Subject Fw: More EBD Review White Papers

Critique of Pebble Limited Partnership's Seismic Hazard Assessment

Executive Summary

Table ES1. Review of Pebble Limited Partnership's (PLP's) Environmental Baseline Document (EBD): Hydrologic characterization

Figure 1: PLP (2012 Ch 6) concludes that the Lake Clark Fault is inactive, and veers away from the mine site. This conclusion is not supported by either PLP's work, or existing literature - the fault's location near Pebble, and its activity, are unknown.

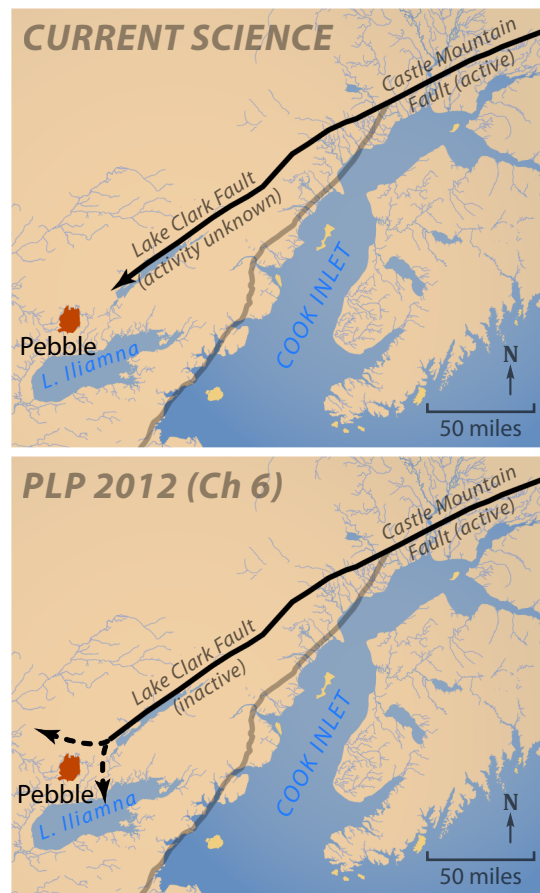
The Lake Clark Fault is a major fault connected to the well-known Castle Mountain fault in south-central Alaska. It trends northeast to southwest, from near Beluga, through the Tlikakila River valley, and then along Lake Clark (Nelson et al., 1983). The fault has not been mapped further southwest than this. Taking the simplest assumption, that the fault continues on its mapped course, it would pass through or near the Pebble prospect (Figure 1).

Glaciers frequently cross faults, including the Lake Clark Fault further to the northeast. Many active faults are not parallel with landscape features (such as ridges and valleys) that typically control glacial flow (e.g. the Seattle Fault, Sherrod et al. 2008). For the Lake Clark Fault to track with glacial advance, it would have to make an abrupt, unusual turn (Figure 1). PLP presents no evidence that the fault actually makes this turn.

Figure 2 (PLP 2012 3.7.3, figure 3-6a): PLP maps the bedrock near Pebble Prospect. Blue lines are small faults in the area. The deposit is outlined in yellow near the northeast corner of the map.

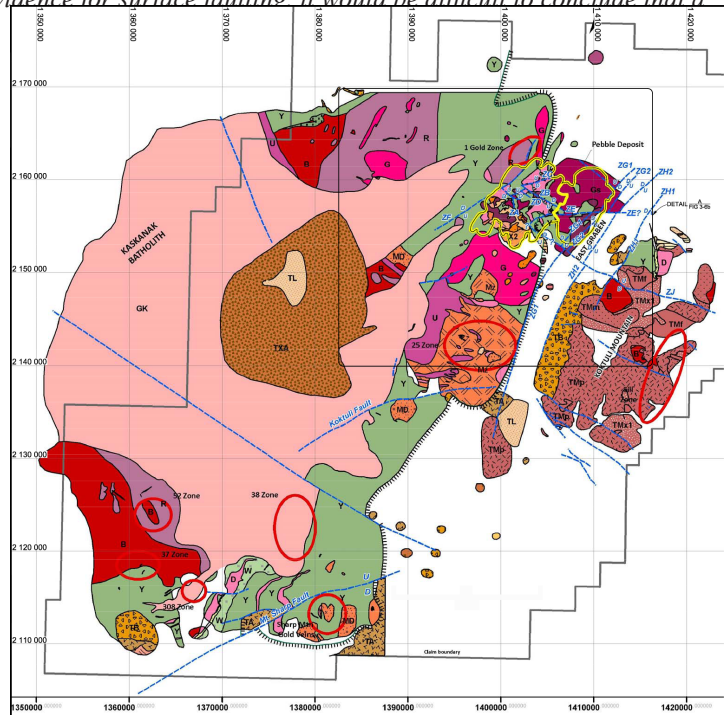
PLP's (2012 3.7.3) geologic map (Fig. 2) shows a number of small faults cutting bedrock in the vicinity of the mine. These faults are not discussed in the PLP (2012 Ch 6) seismic hazard assessment.

PLP (2012 3.7.3) maps several parallel small faults that have allowed a wedge of bedrock to shift downward, a "graben," within the mine area. In their 2006 mine plan (DNR, 2006), a tailings dam is planned directly over this graben. This is a scenario where a fault might be activated by a human activity. Grabens form where the earth stretches, and large blocks of bedrock sink downwards along faults. Since the weight of a tailings facility would apply increased downward pressure to this graben, it has an increased chance of triggering an earthquake (McGarr et al. 2002).

Figure 1. Water balance results for SK100F. Note that there is general correspondence between the water balance predicted and observed flows.

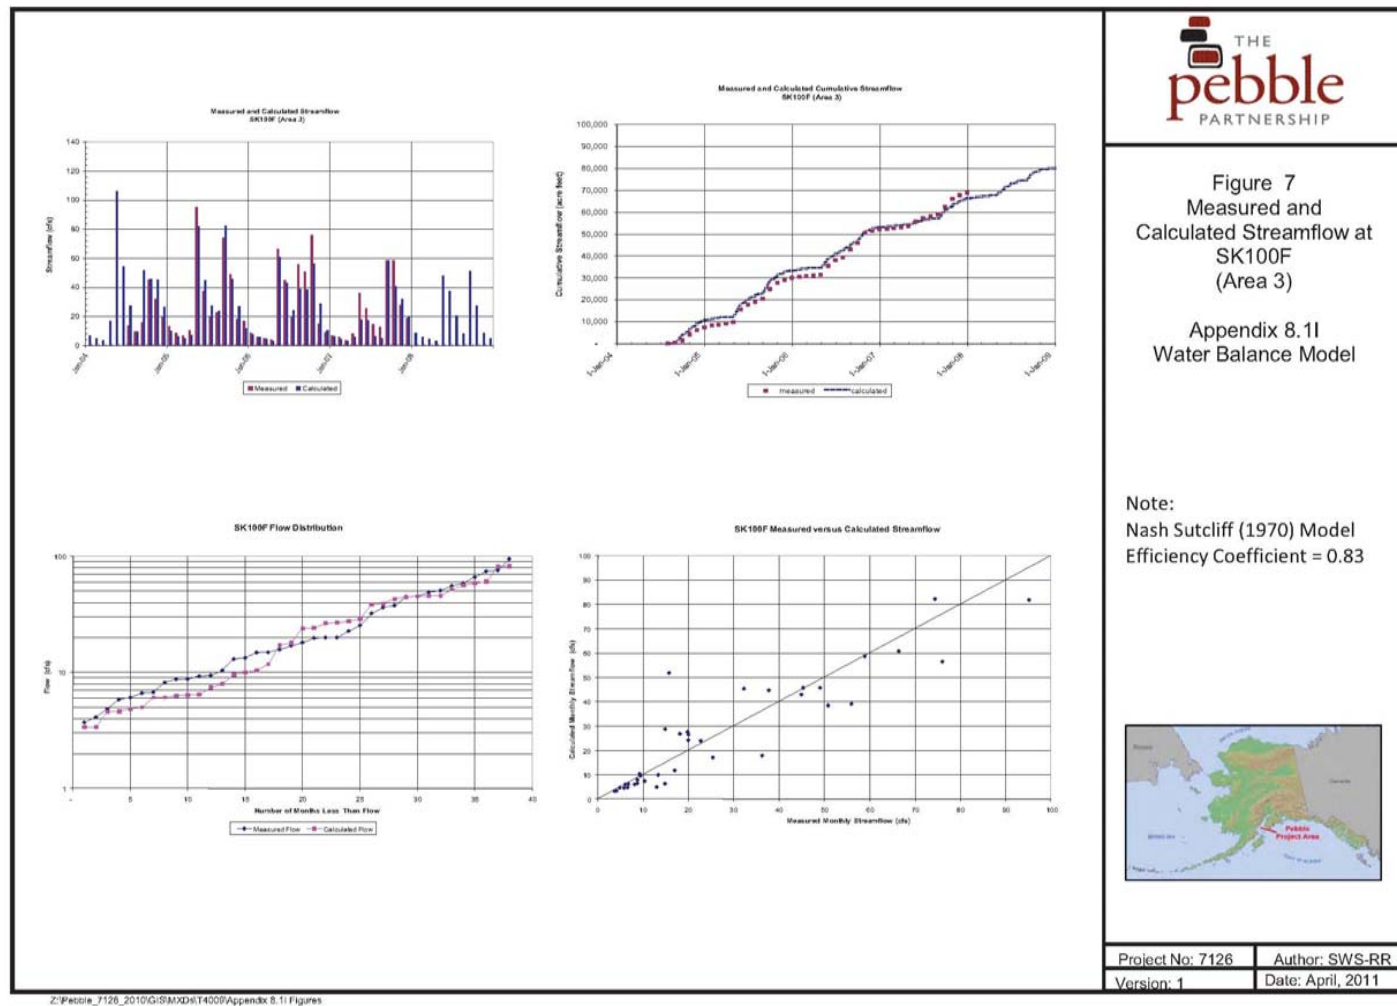
Despite an extensive hydrologic data collection program, the only measured parameters used in the water balance are streamflow and groundwater elevations. All other variables are adjusted so that the remaining inputs and outputs to the hydrologic system match these parameters. From Chapter 8, page 26 of the EBD:

Using this method, the modeled inputs and outputs to the hydrologic system are essentially guaranteed to balance, as presented in Appendix 8.1I. However, given the mismatch between *measured precipitation* and *measured streamflow* as described above, it is questionable whether this calibrated water balance paints a realistic picture of the hydrologic system. The water balance model requires between 40 and 55 in. per year of annual precipitation (an amount that varies by sub-catchment) in order to supply enough water to the system to match the measured streamflow. Yet the measured annual precipitation over the three years of monitoring is only 30–39 in. (EBD, Chapter 2). Thus, either the measured precipitation at the site is 25–40% too low or the measured streamflow at the site is 25–40% too high. It is nearly impossible to tell based on existing data which of these errors underlies the hydrologic imbalance at the site. However, given the magnitude of the discrepancy, it is clear that PLP must resolve this issue.

Figure 2. Comparison of field-measured hydraulic conductivity values to values used in PLP's groundwater model.

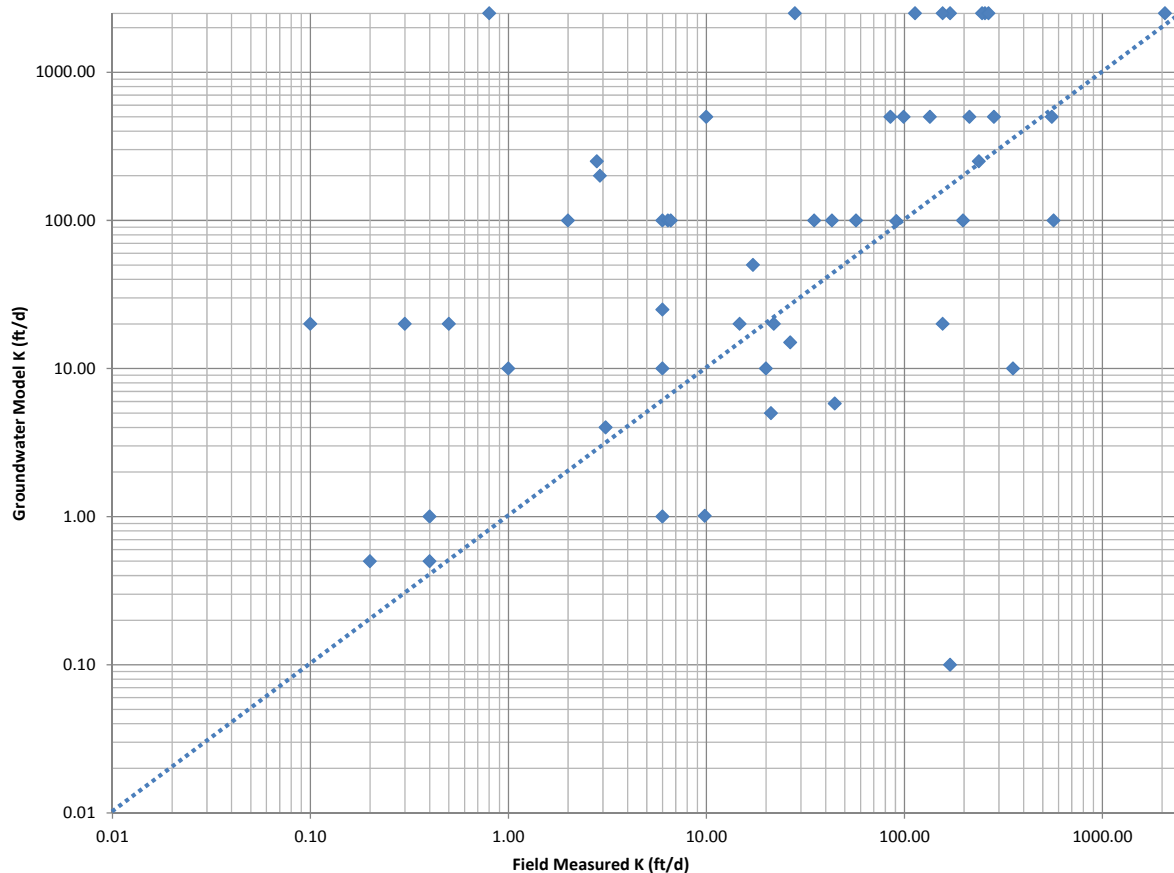
The remainder of Appendix 8.1J presents the results of the numerical groundwater model calibration, reporting statistics on goodness-of-fit, root-mean-square (RMS) errors, etc. However, these calibration statistics reflect the correspondence between the numerical groundwater model and a flawed water balance because *measured precipitation* is too low to explain *measured streamflow*, as described above. In addition, the numerical groundwater model is over-parameterized relative to the amount of data available. The model domain is broken into 644 hydraulic conductivity “zones,” for which the hydraulic conductivity values used in the model have little to no relationship with field-measured conductivities. For example, Figure 2 is a plot of the hydraulic conductivity values used in the groundwater model vs. field-measured hydraulic conductivities. In general, the model values do not correspond at all to the field-measured values, indicating that the calibrated groundwater model ignores field-measured data.

Thus, while the EBD presents a numerical model that appears to be well-calibrated, the number of parameters and the values required to achieve this calibration often have little relation to field-measured data. This could have significant implications when using this calibrated model to evaluate changes in hydrology related to mining. In particular, since the model inputs are not true to available site data, the model may have no predictive capability at all when used for impact analysis (U.S. EPA, 2003).

Figure 3. Hydraulic heads (piezometric levels) measured across ZE fault. Note significant change in head across the ZE fault (~ 1,500 ft), demonstrating the control of this fault on groundwater flow.

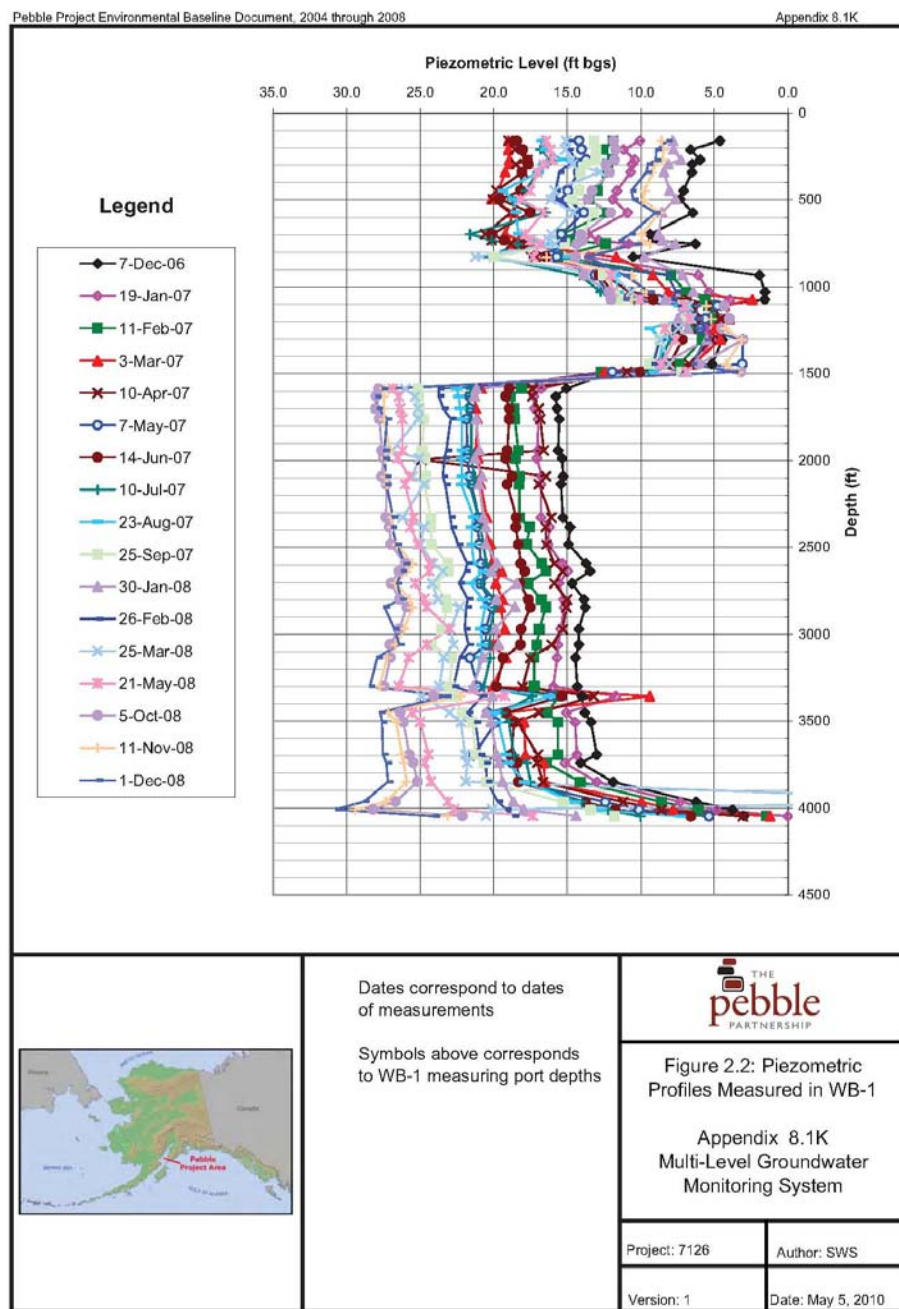
Third, the groundwater model does not incorporate the influence of faults on bedrock groundwater flow. The available data from tests in deep boreholes indicate that at least one of the major identified faults crossing the deposit area (the “ZE Fault”) exerts a strong control on groundwater flow: hydraulic heads rise approximately 20 ft across this fault, which indicates that groundwater is under pressure beneath this fault zone (Figure 3). This fault and other deep bedrock faults that would be intersected by a pit are clearly influencing groundwater around the deposit area, and could be conduits for groundwater flow. This suggests that these faults could make it difficult to maintain a capture zone around the pit both during and after mining. As currently presented, the groundwater model makes no mention of faults at all, calling into question PLP’s ability to predict the impacts of mining on groundwater. PLP must model the influence of major faults on groundwater flow, particularly near the pit where they could represent conduits for contamination to escape to downgradient surface water and groundwater resources.
